Re: **The Parklands Village V2F1 – Site Plan and Plat - Response to Comments (2022-4054-00; 2022-3092-00)**

FIRST TECHNICAL REVIEW

PLANNING DEPARTMENT COMMENTS – DEBORAH BICKMIRE

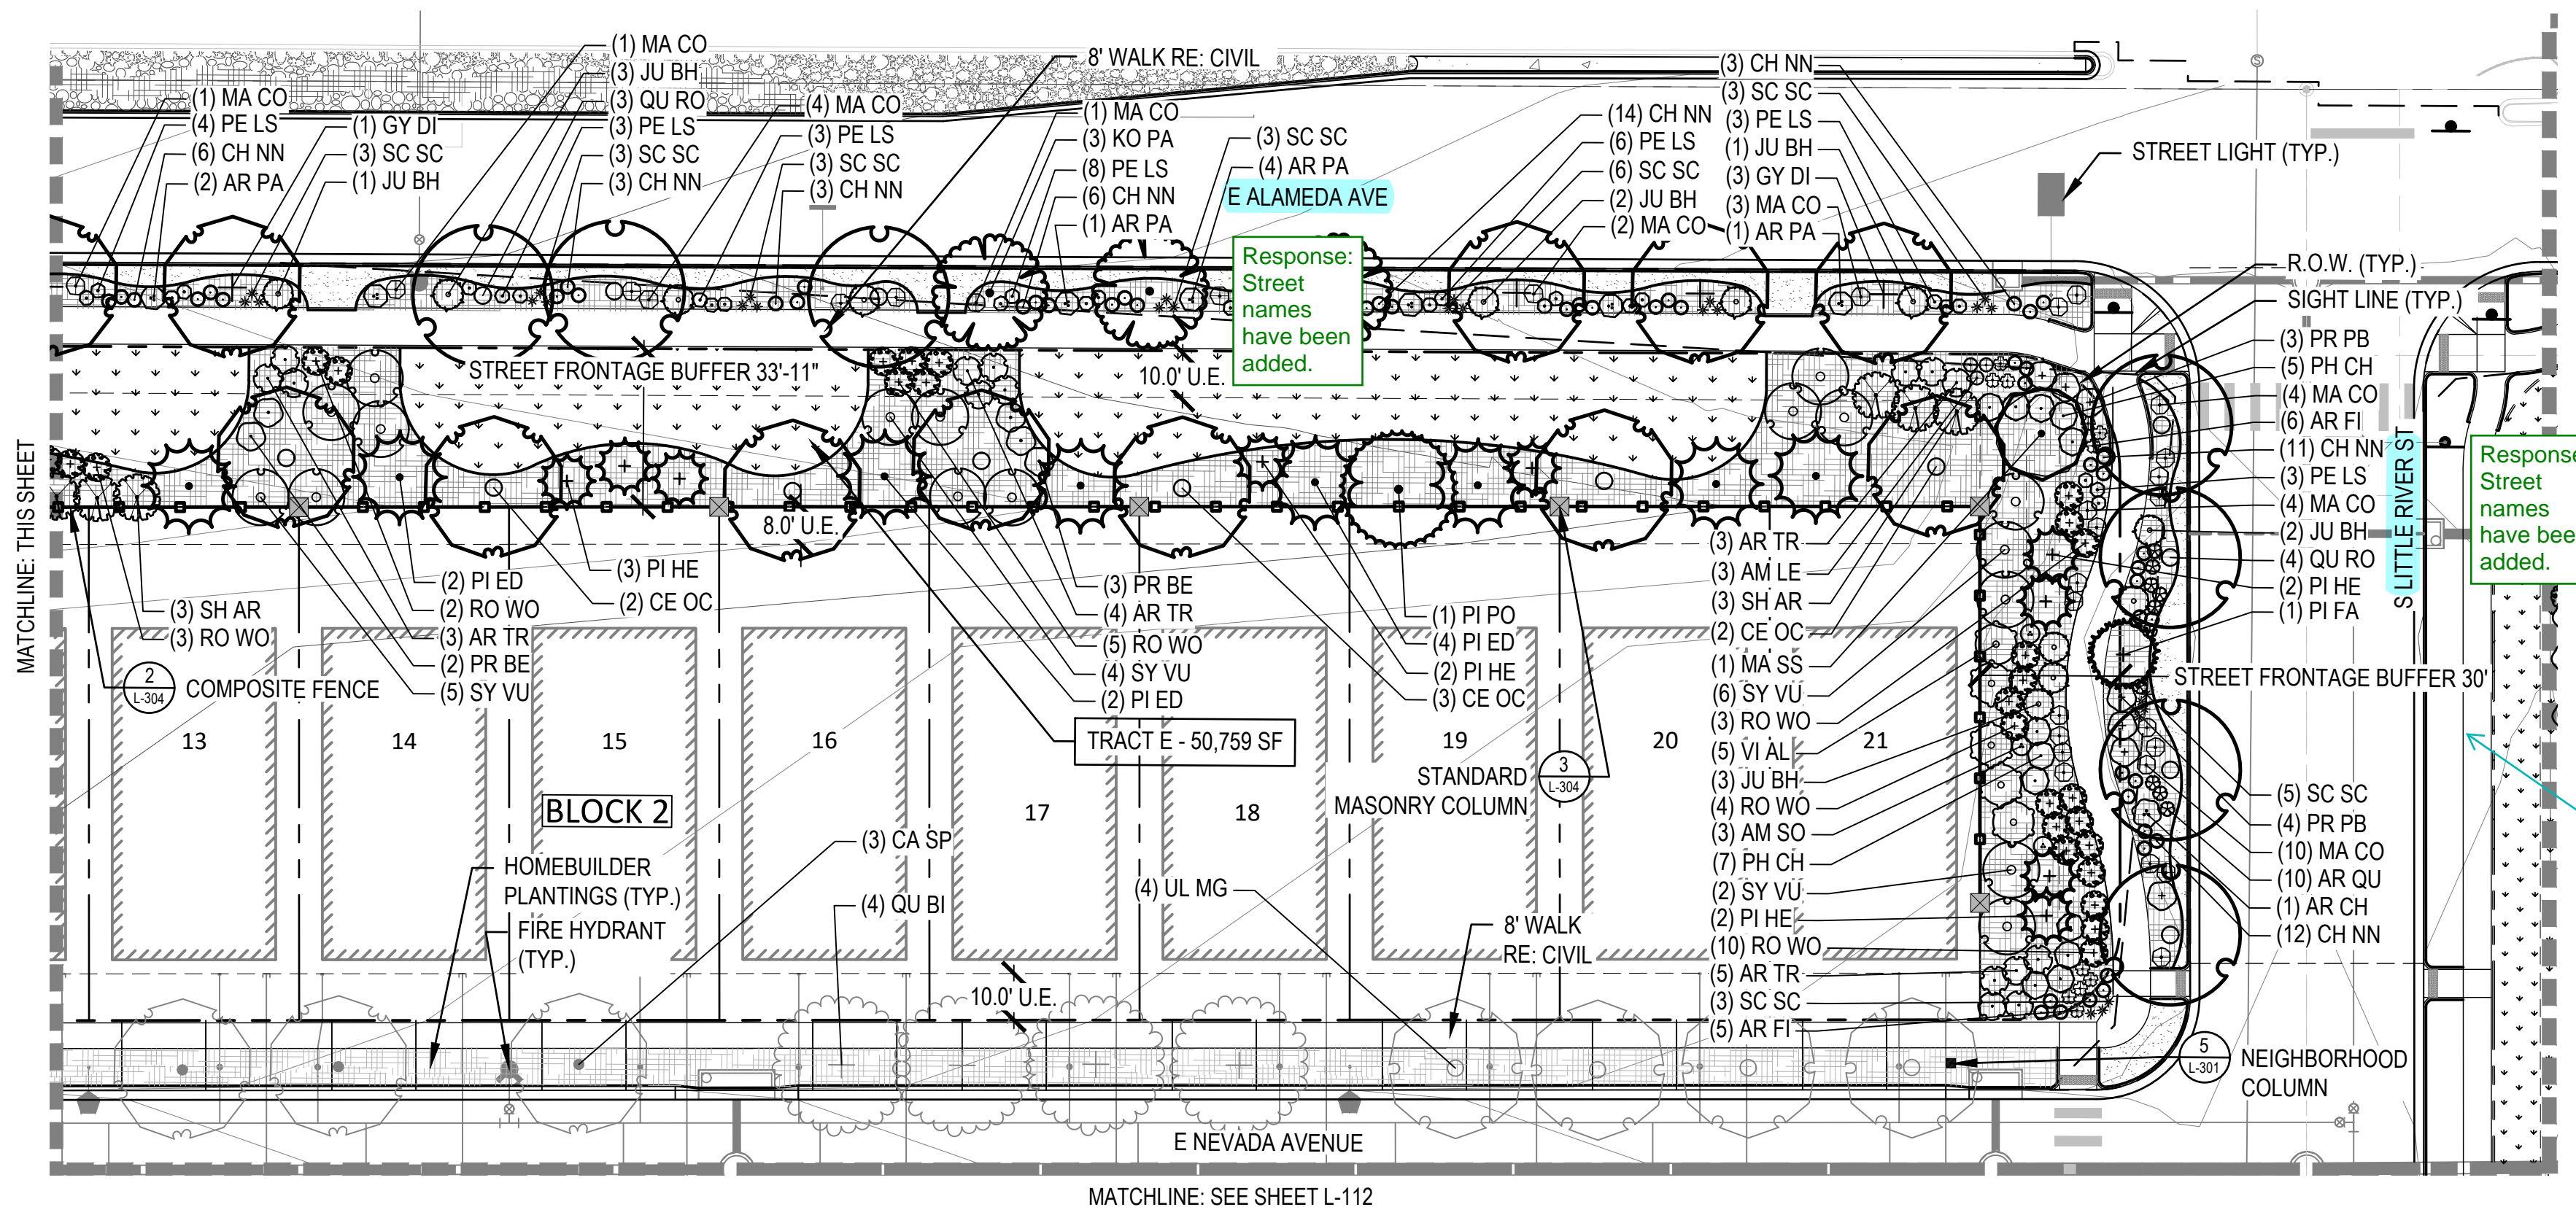
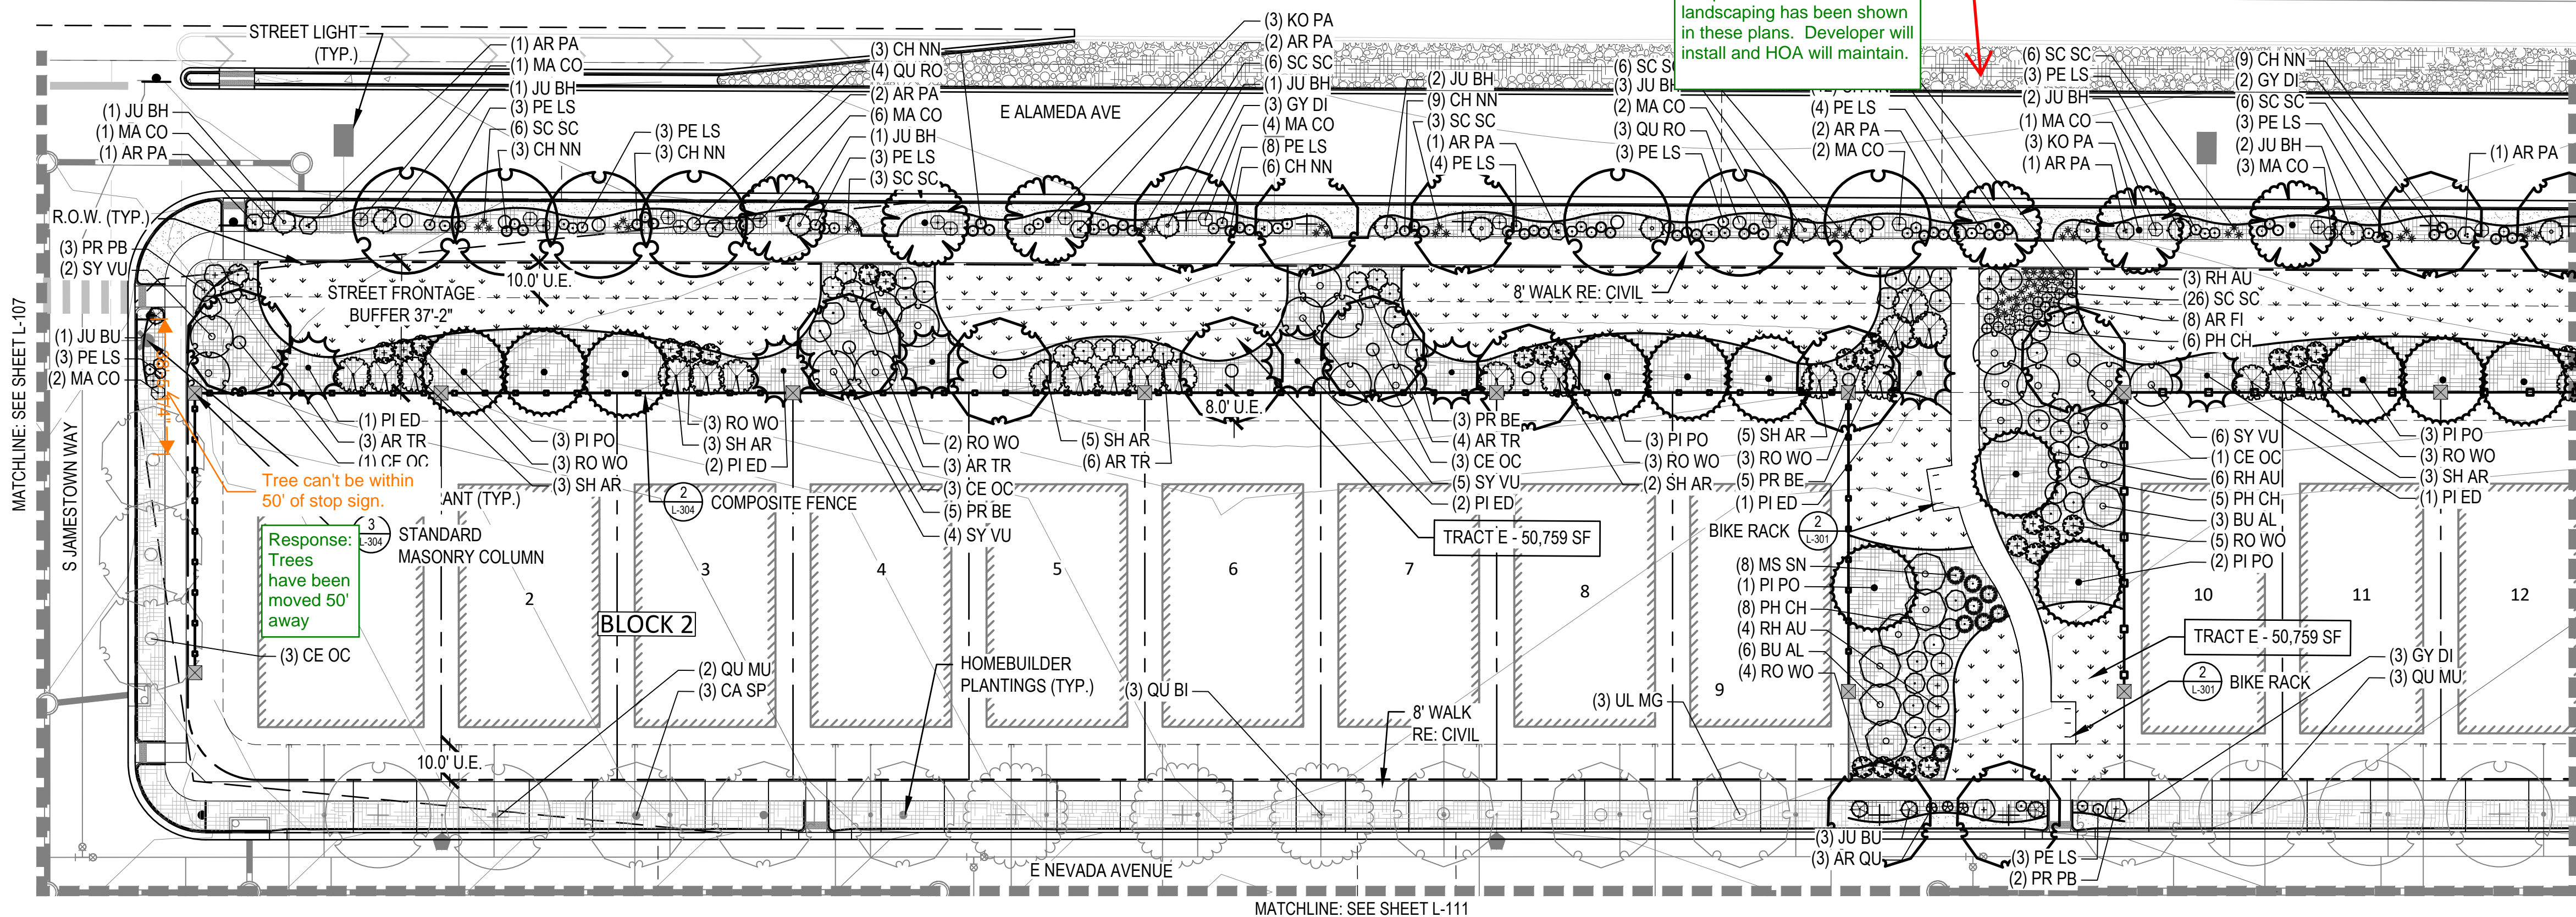
Was the median landscaping provided with a previous ISP or is it being designed in connection with this application? Please provide the Case Number and title if this was previously approved.

why is the curbside not included? There is landscape provided for the pond on sheet L-117 and the pond is not temporary.

Response: Median landscaping has been shown in these plans. Developer will install and HOA will maintain.
